Re: Conservancy Oil, 2220 2nd Street SW, Traffic Circulation Layout, Engineer's Stamp dated: 12-23-05 (L14-D39)

Re: Conservancy Oil, 2220 2nd Street SW, Traffic Circulation Layout, Engineer's Stamp dated: 12-23-05 (L14-D39)

Re: Conservancy Oil, 2220 Second St. SW

Grading and Drainage Plan

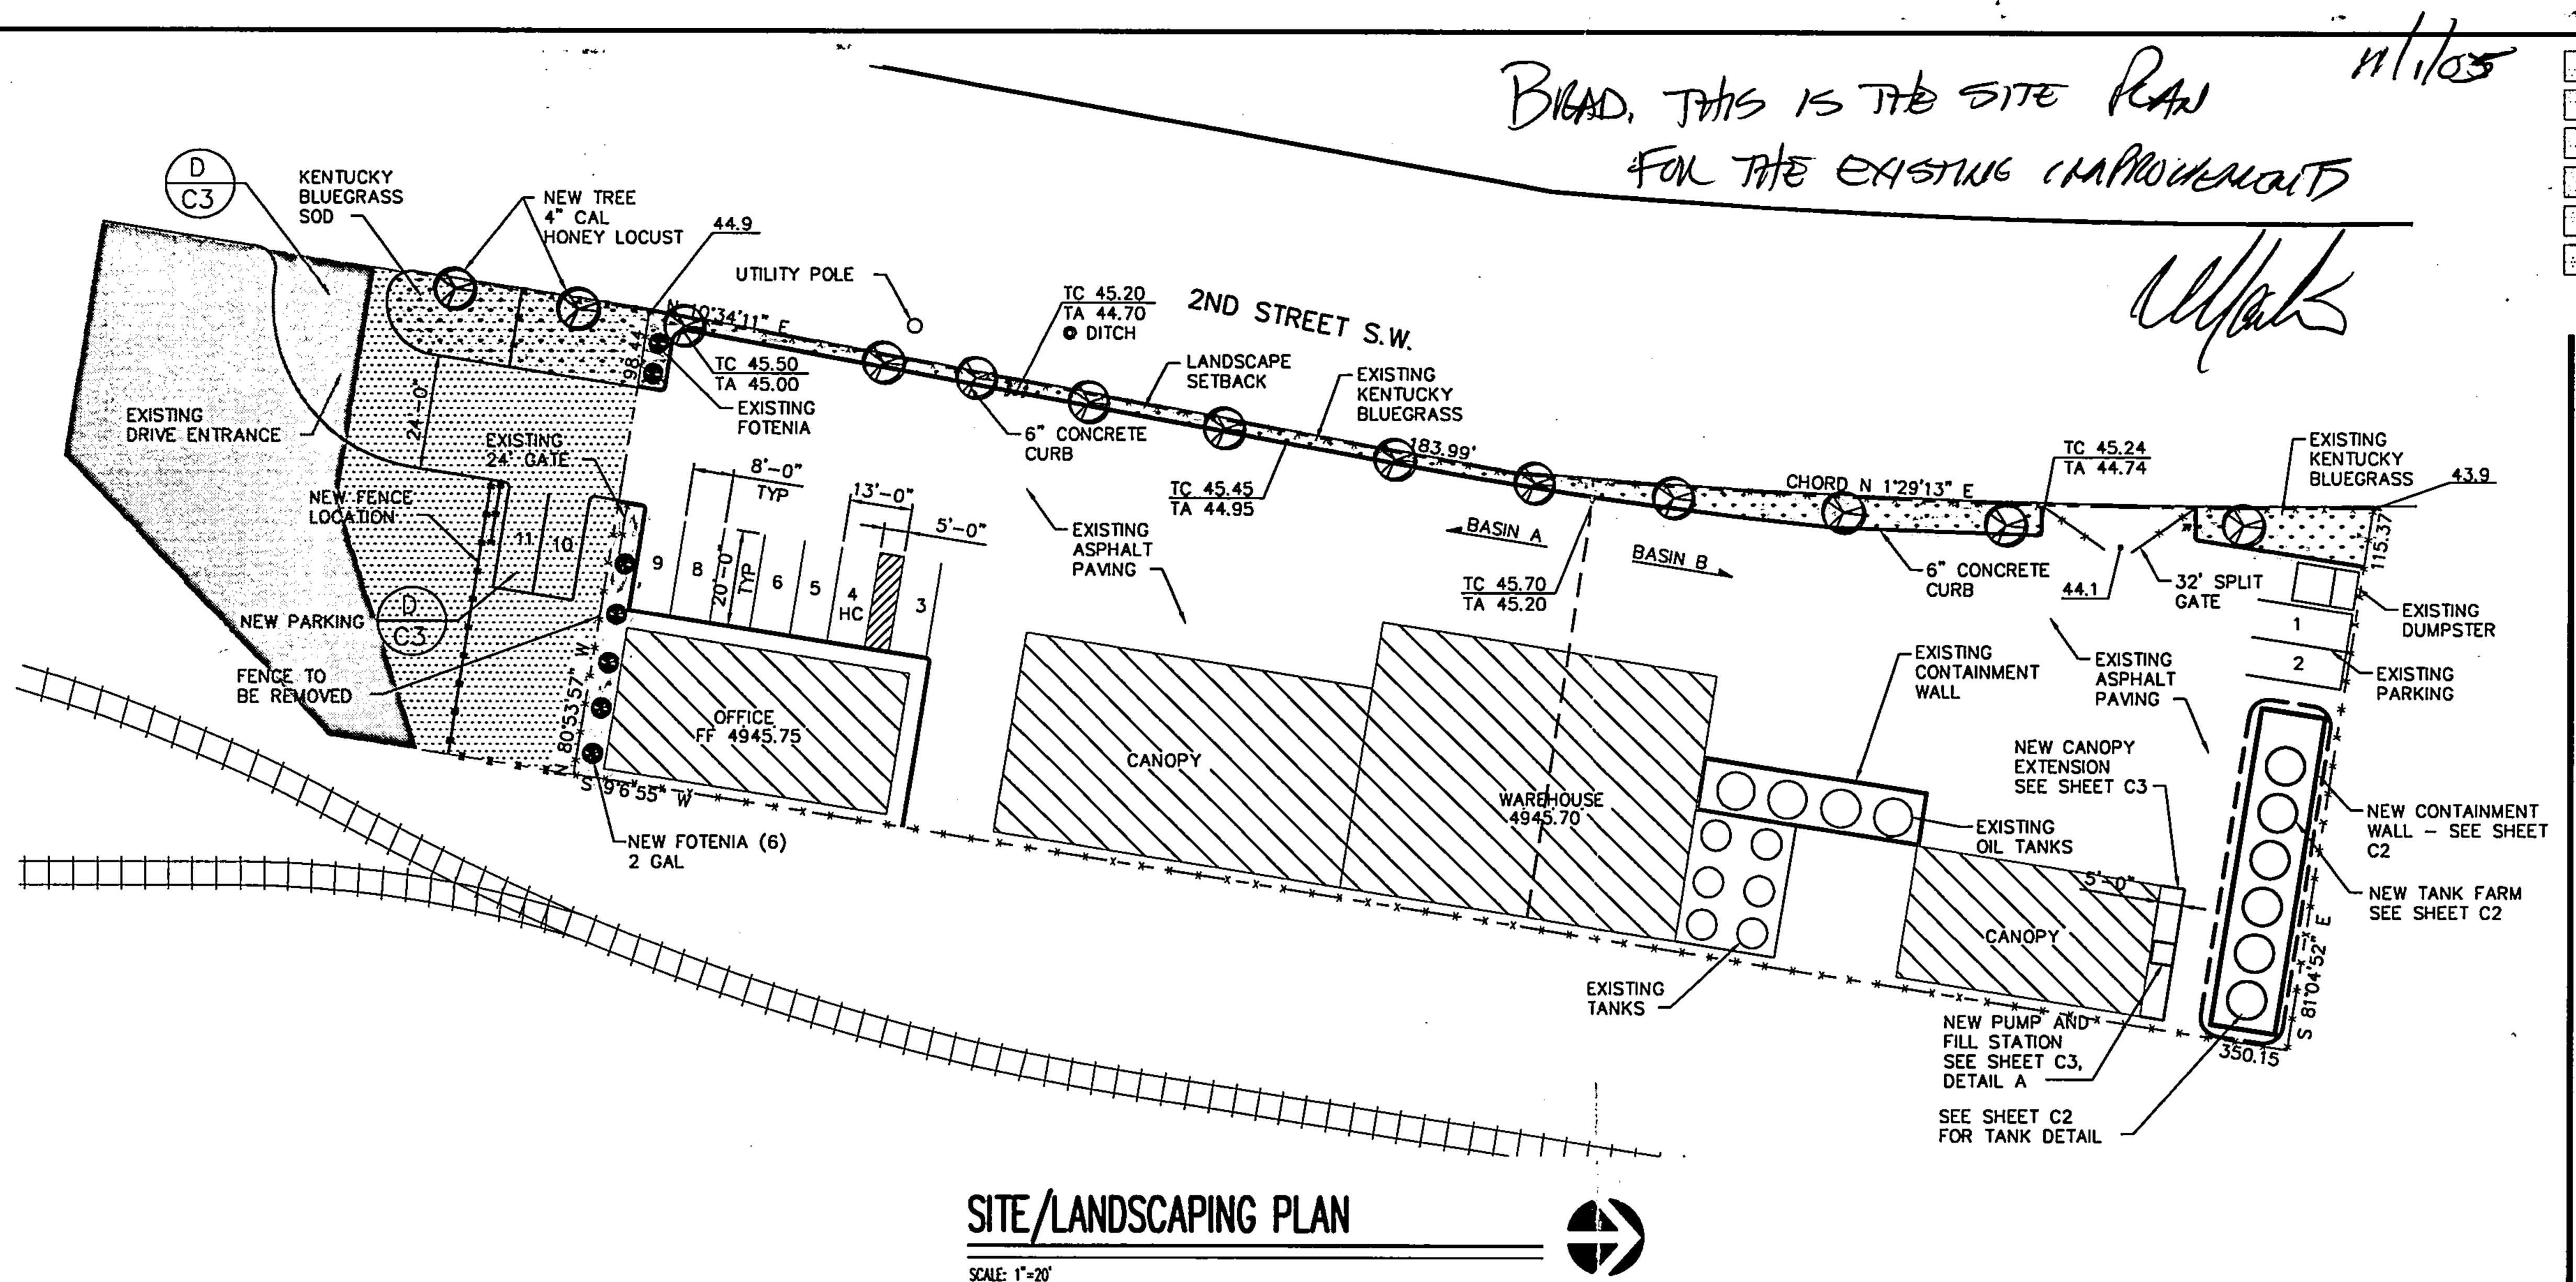
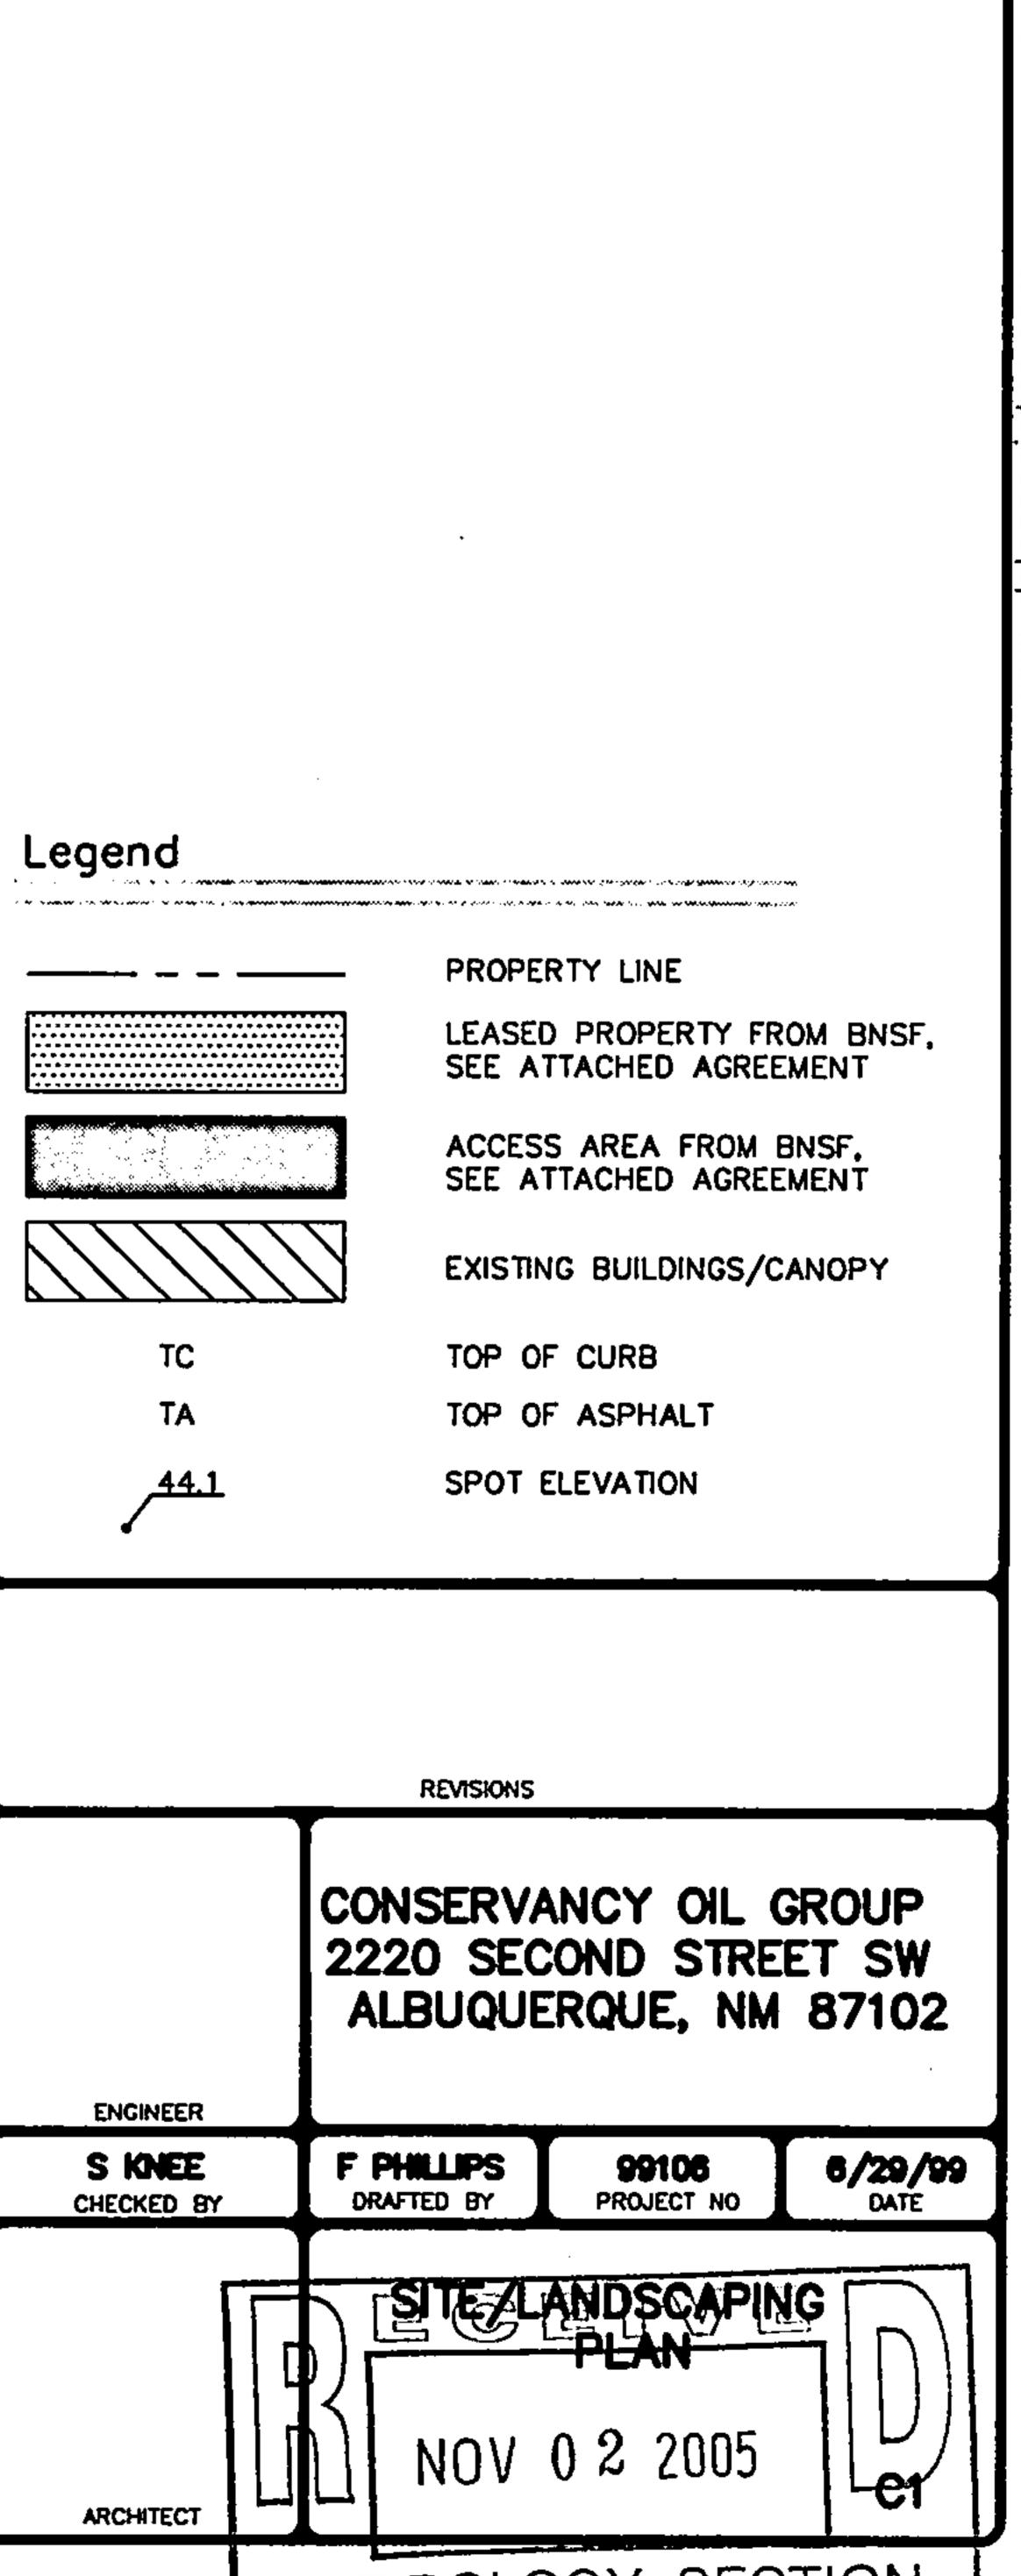
- 1. How is the flow coming off of the buildings?
- 2. The Channel needs to be labeled.

- 3. Is this site all paved?
- 4. Where is the landscaping located?
- 5. How was less type D land treatment reached when more roof area was added?

- 1. How is the flow coming off the buildings? The building rooftops slope toward the east property line. The runoff then flows south between the office buildings and the warehouse, then west to the rundown. The slopes have been added to the plan.

- 2. The channel needs to be labeled. The channel has been labeled on the plan.
- 3. Is this site all paved? The site is all paved except for the area east of the buildings which is gravel, and the landscape area along the west property line. The storage tank containment areas are concrete.

- 4. Where is the landscaping located? The landscaping is located along the west property line. I have included an 11x17 of the site prior to these proposed improvements. The landscaped area is highlighted in green.

- 5. How was less type D land treatment reached when more roof area was added? The net additional roof area over the existing roof area is almost the same amount. The reduction in type D land treatment comes from the construction of the new containment area around the new tank farm. This containment area is not allowed to drain, thus the water that falls in the area stays in the area, and thus reduction in runoff from type D land treatment. I have included an 11x17 copy of the existing site that shows the existing rooftop versus the proposed rooftop with the new plan.
